# ALESIS MMT-8 (MT) Service Manual

P/N: 8-31-0018-A

## ECN HISTORY

ECN# 007201 SH. 1 OF 1

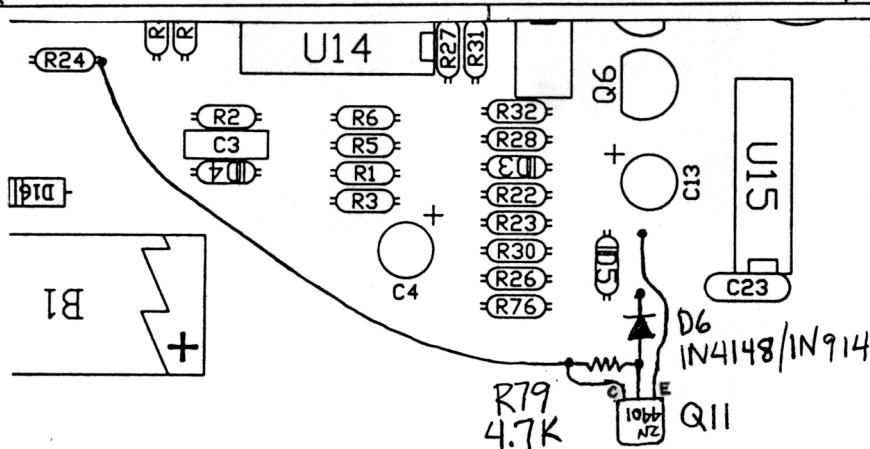
DESCRIPTION OF CHANGE: ADDITION OF THE FOLLOWING PARTS TO UNITS USING  
'257 SRAMS ONLY:

(1) - 4401 TRANSISTOR - Q11

(1) - 4.7KΩ RESISTOR, R79

(1) - JUMPER (SEE BELOW)

REASON FOR CHANGE: CRASHING MEMORY DUE TO VOLTAGE DIFFERENCE  
BETWEEN DATA LINES & SRAM VCC.
